## ADDENDUM NO. 2

PROJECT: Bannack State Park Detention Basin Project

FWP PROJECT #: 7116103

DATE: 02/28/17

SHEET  
1-3

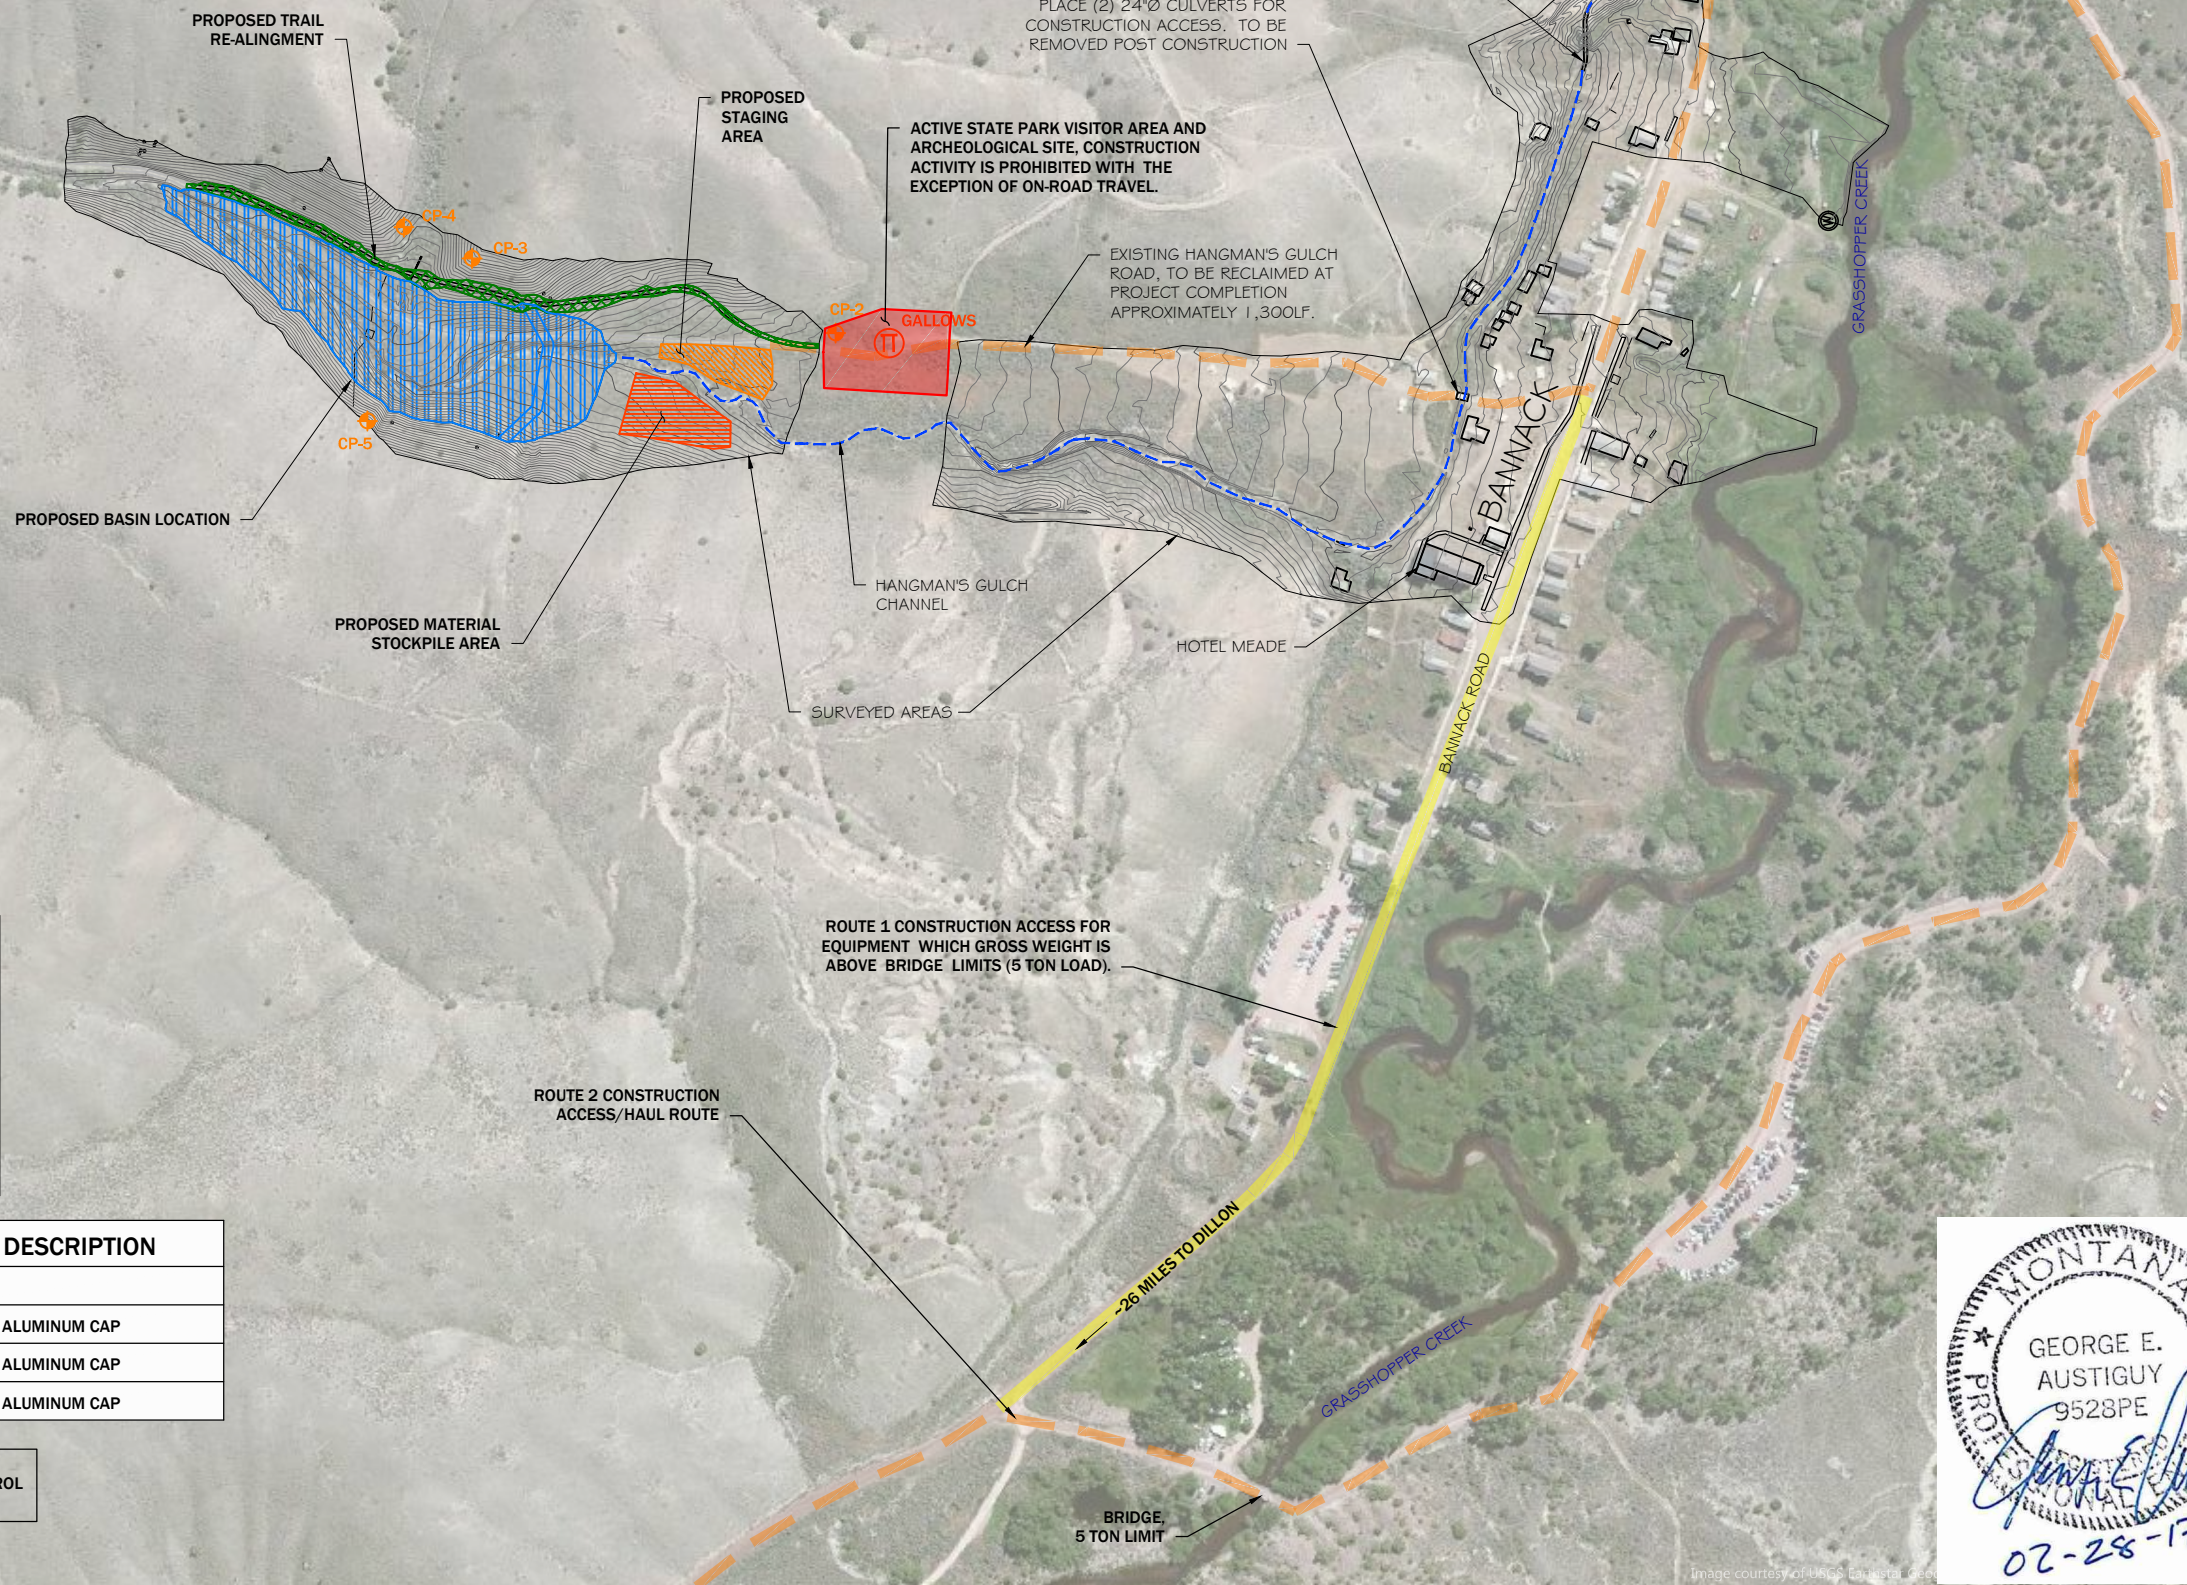
1. **Sheet 1-3:** Added approximate length of road to be reclaimed after work is complete.
2. **Sheet 4-6:** Added permissible construction joint locations.
3. **Sheet 5-2:** Updated quantity table to include inlet channel over-excavation, added maximum excavation slope of 1.5H:1V for over-excavation note and added cross sectional areas for clay layer and overburden material.
4. **Sheet 5-7:** Added Fence Typical Detail.
5. **Sheet 6-1:** Revised quantity table and areas to clarify quantities and to reflect a more accurate estimate of proposed work.

**Response:** The areas on the lower left hand side of sheet 6-1 include the embankment/basin, trail re-alignment, staging and stockpile areas. The access route is along an existing road and is to be reclaimed to pre-construction condition. The extent of reclamation on the road is dependent on the extent of disturbance and widening required for the Contractor to access the site. It is ~1,300 lf from Bannack Road to the start of the trail re-alignment.

SHEET  
4-6

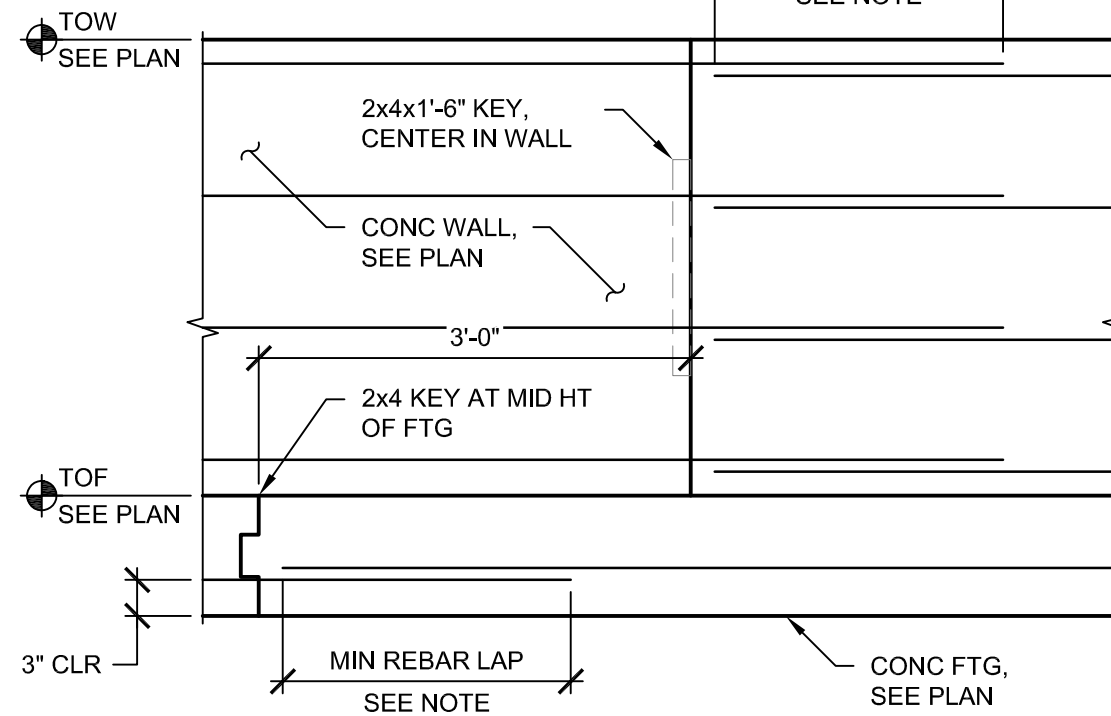
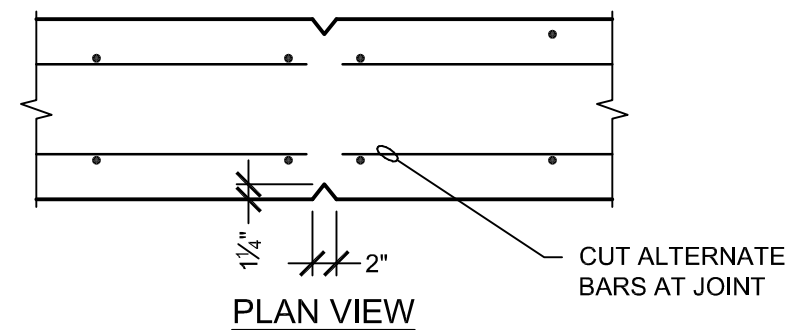
4. **Question:** Are construction (cold) joints permissible on the outlet structure?

**Response:** Yes, construction (cold) joints are permissible per sheet 4-6.

- NOTE:
1. ESTABLISH CONTROL JOINTS AT 20'-0" OC MAX SPACING
  2. JOINT LOCATION TO BE APPROVED BY ENGINEER
  3. EXTEND CJ ALONG TOP SURFACE & DOWN BACK SIDE WHERE EXPOSED TO VIEW
  4. HORIZONTAL CONSTRUCTION JOINTS TO BE PLACED AT HALF OR THIRD POINTS OF WALL. PROVIDE CONT 2x4 KEY.

SHEET  
5-2

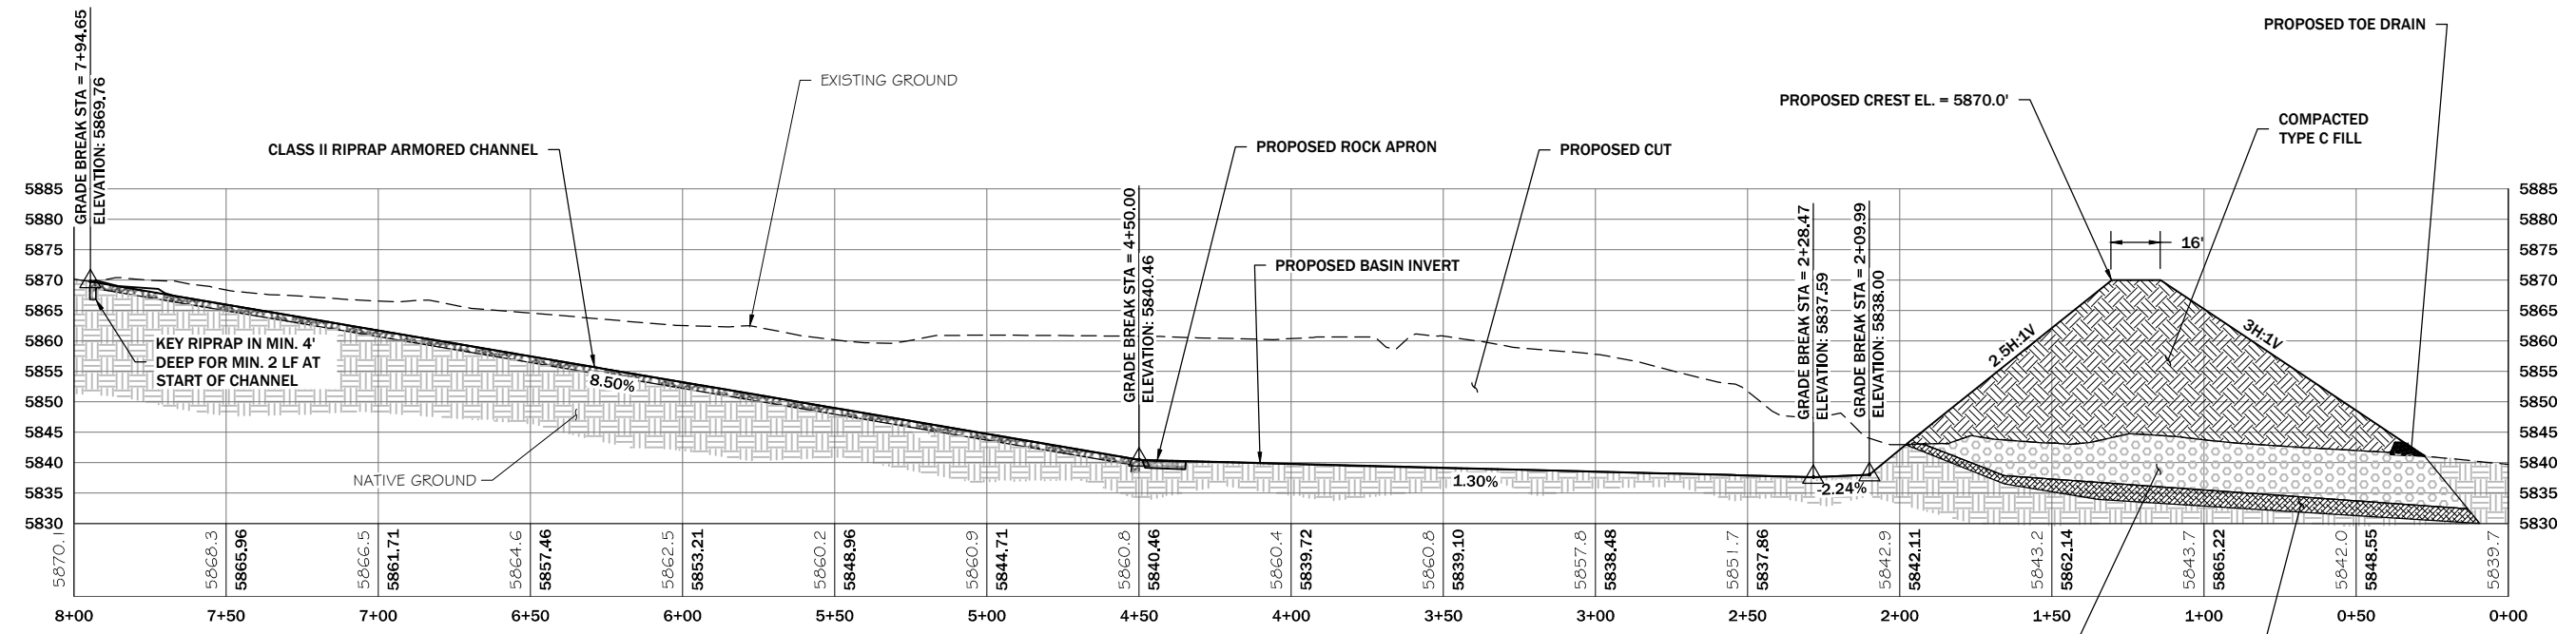
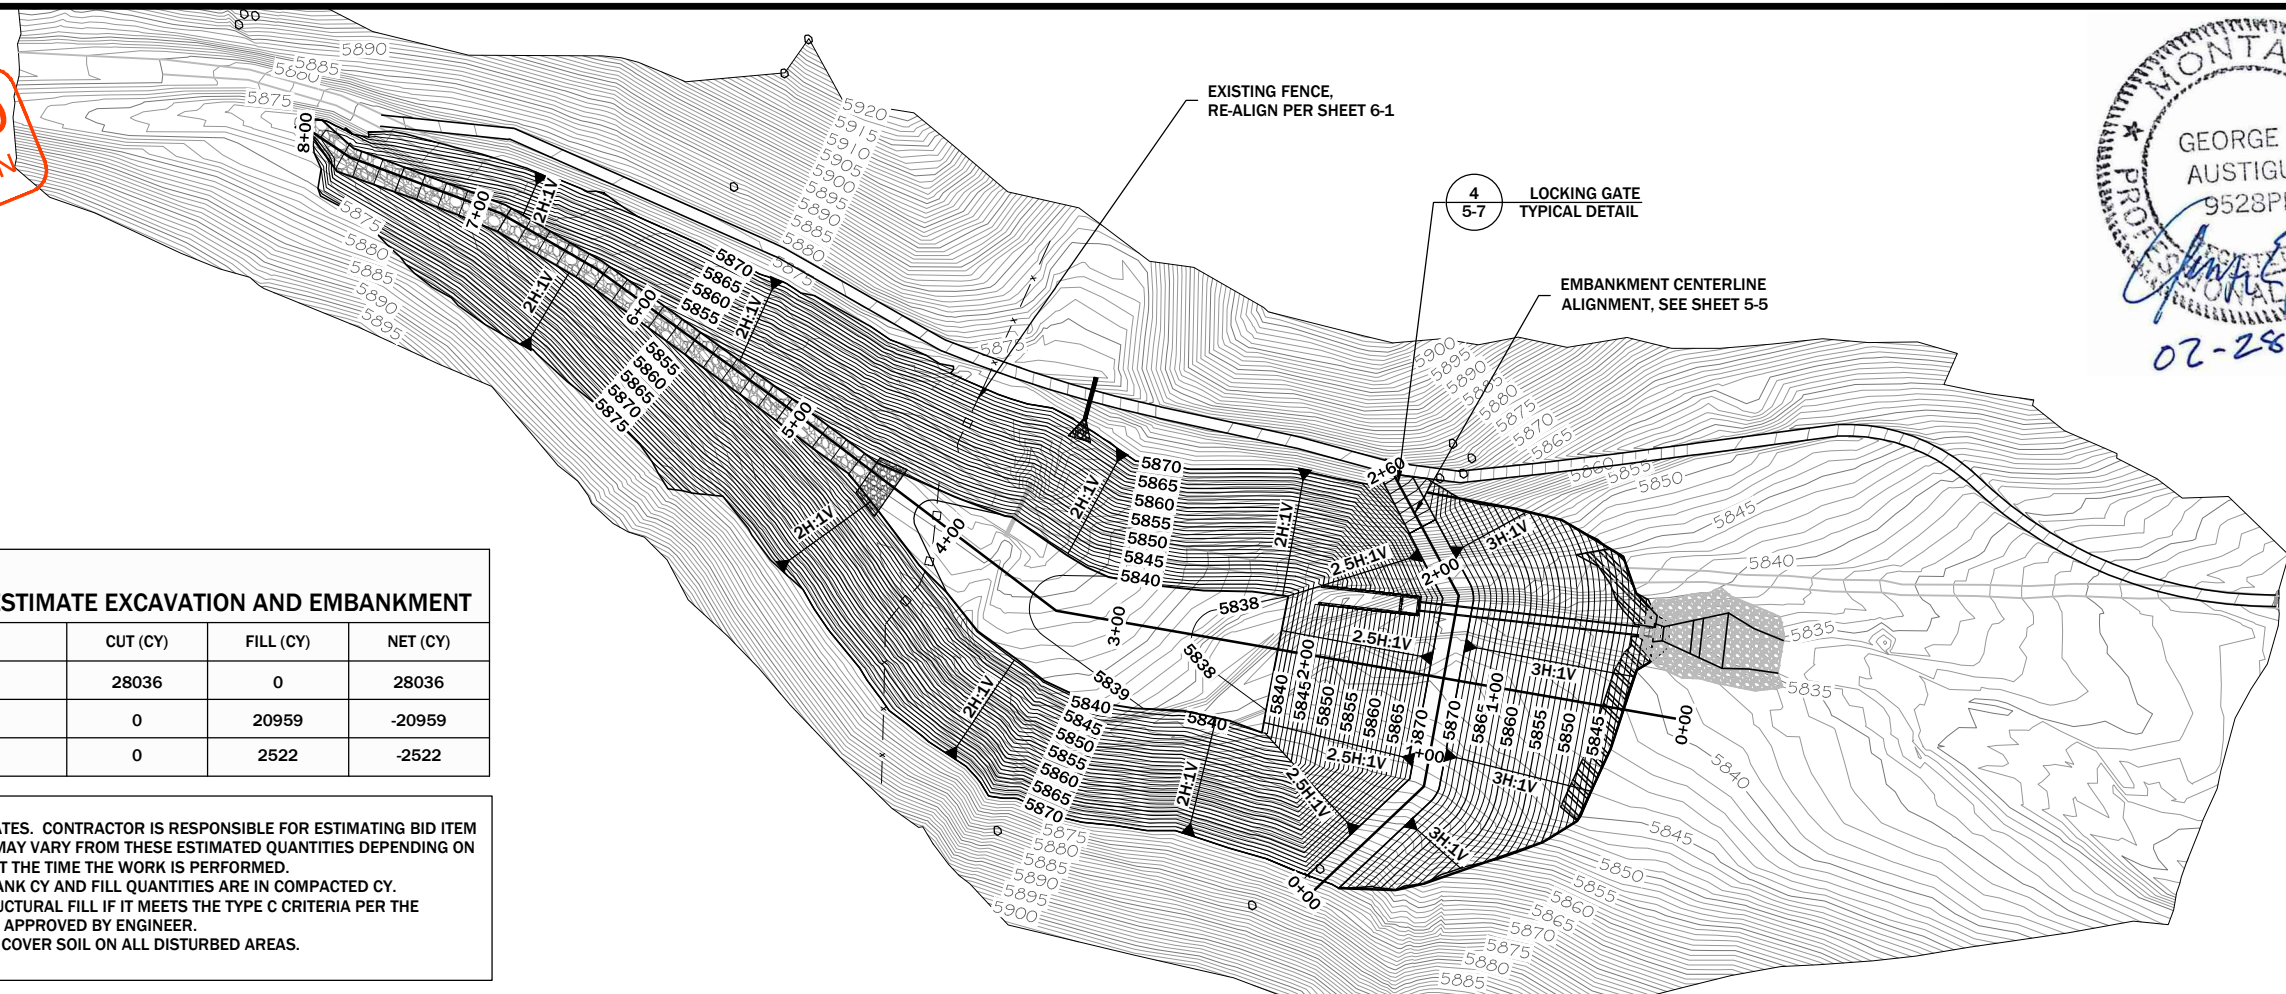
1. **Question:** What is the extent of the clay area to be removed, and how were the limits determined?

**Response:** The extent of the clay layer was estimated using data from Test Pit-07, Borehole-03 and Borehole-02. A clay cross sectional area (415sf) and overburden cross sectional area (1,206.5sf) was estimated from the profile on sheet 5-2 and applied across the floodplain (~100ft).  $((415\text{sf} + 1,206.5\text{sf}) * 100\text{lf}) / 27 = 6,005.6\text{cy}$ , a 10% contingency was added to reach 6,606cy as shown on sheet 6-1.

ALLUVIUM MATERIAL TO BE OVER EXCAVATED (ESTIMATED CROSS SECTIONAL AREA = 1,207SF) AND REPLACED AS TYPE C COMPACTED FILL

CLAY LAYER EXCAVATE AS DIRECTED BY ENGINEER (ESTIMATED CROSS SECTIONAL AREA = 415SF). MAXIMUM EXCAVATION SLOPE = 1.5H:1V.

TYPE B GEOTEXTILE  
STAKING DETAIL  
SCALE: 1" = 6'

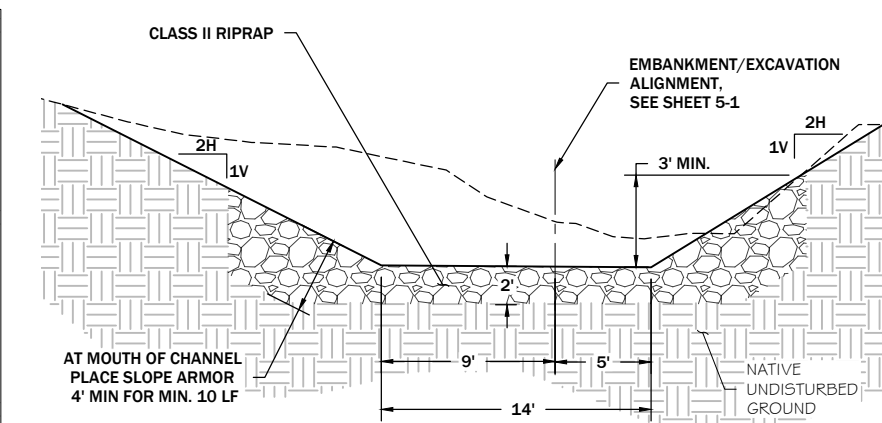
23. **Question:** The Detail on Sheet 5-7 shows wood stakes being used but, the note in the middle of the page says wood stakes are not allowed on compacted embankment?

**Response:** Wood stakes are not allowed on the compacted embankment. Wood stakes are hard to drive into compacted fill and can compromise the embankment over time. Manufacturer provided metal stakes or Engineer approved alternate shall be used for the embankment and only driven through the 6 inches of Type F material. Wood stakes may be used on any excavated/native ground.

- NOTES:
1. WOOD STAKES MAY NOT BE USED ON COMPACTED EMBANKMENT. USE MANUFACTURER PROVIDED STAPLE OR ENGINEER APPROVED EQUAL ON COMPACTED EMBANKMENT.

FENCE  
TYPICAL DETAIL  
SCALE: NTS

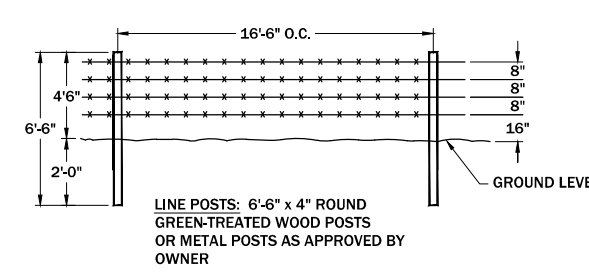
19. **Question:** Is the fencing 4 or 5 strand fence. Can you please provide a detail of the fence?

**Response:** The new fence shall be minimum 4 strand, per sheet 5-7.
